ONE COURSE CEMENT CONCRETE SIDEWALK,
(WITH GRANITE CURB)

REVISIONS AND CORRECTIONS

PLAN AT COMMERCIAL DRIVE

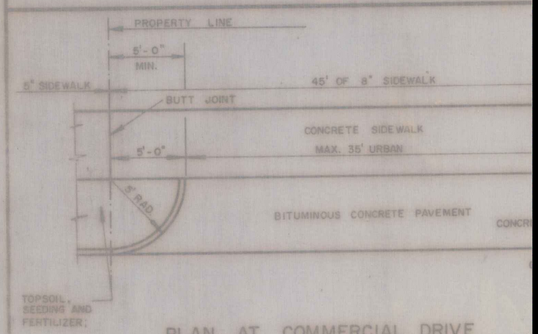
THIS SHEET AND C-2-a, SUPERCEDE SHEET C-2 APPROVED MAY 26, 1958
DETAILS OF GRANITE CURB ENDS CHANGED JUNE 16, 1959
DIMENSIONS FOR COMMERCIAL DRIVES CHANGED FROM 30' TO 35' URBAN SEPT 25, 1959.
DIMENSION 'F' FOR SKEW DRIVE MADE PARALLEL TO ROAD CENTERLINE AND DISTANCE TO PROPERTY LINE AND BETWEEN DRIVES, NOTED OCT. 13, 1959
